From: McConnell, DAVE P <dave.p.mcconnell@lmco.com>
Sent: Saturday, December 31, 2016 7:38 AM
To: Grant Robinson
Cc: Peter Bruce; Craig Roberts; Nakhon Supervisor Engineer
Subject: 920279 Oil puddle in TR PCS

Case Number: C0049343
Customer: Thai Aviation Services Limited
Aircraft S/N: 920279
Aircraft Model: S-92A
Aircraft TT: 574
ATA: 64
Part Number: 92358-06303-042
Case Subject: ASB 92-64-010 TR PCS Bearing Oil Puddle

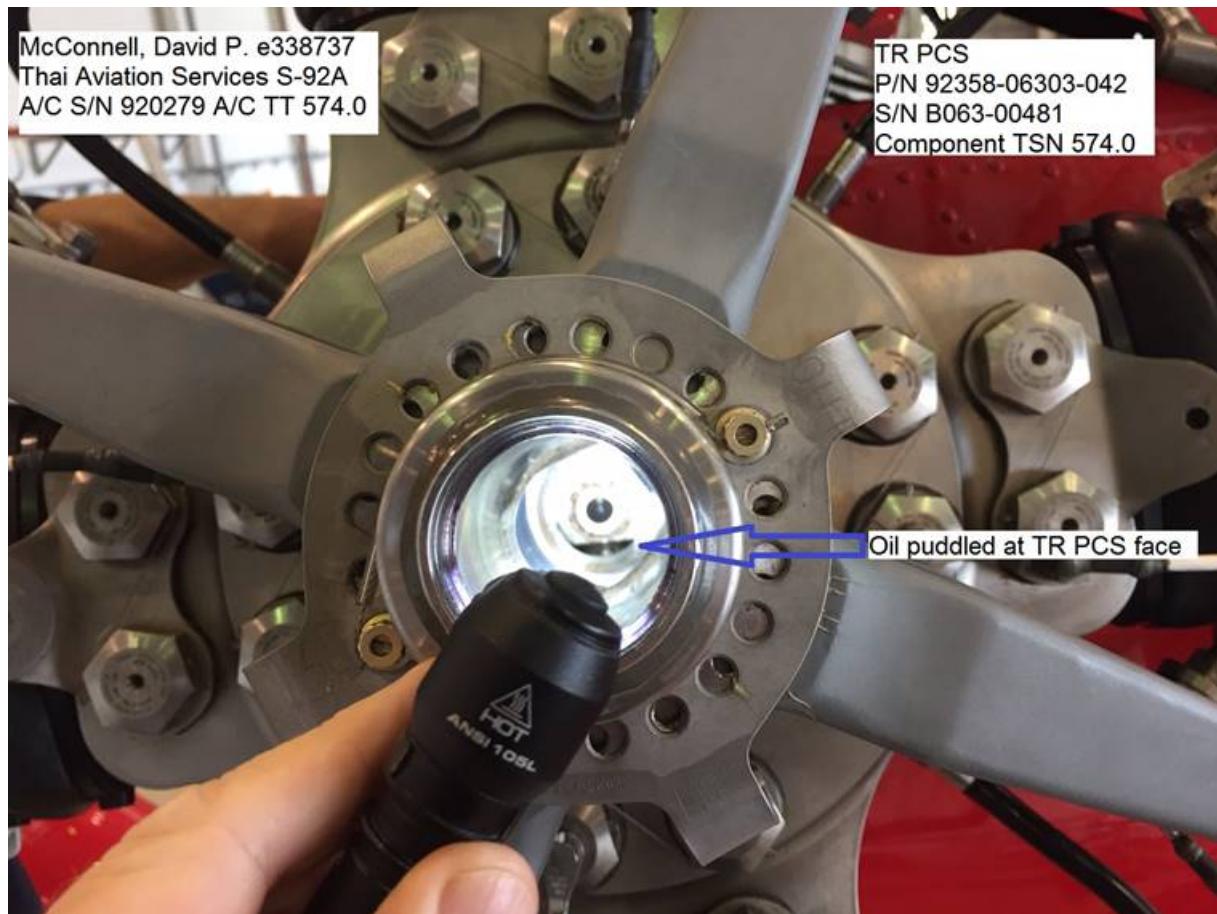
TAS maintainers pulled the plug at the end of the PCS and note oil puddling at the face of the TR PCS bearing.

A borescope inspection of the opposite side of the bearing indicates an accumulation of wet, darkened grease.

TAS request confirmation that these visual indications are normal indications for a TGB that is being filled to the top and soaked periodically for six hours per the ASB.

Sikorsky Engineering states that we expect the oil to seep through the bearing over the six hour period, just as we expect it did during storage. The periodic procedure of filling with oil is to ensure that the bearing maintains lubrication in the condition where the grease has diminished. We remind that the procedure is temporary until a new PCS is available.
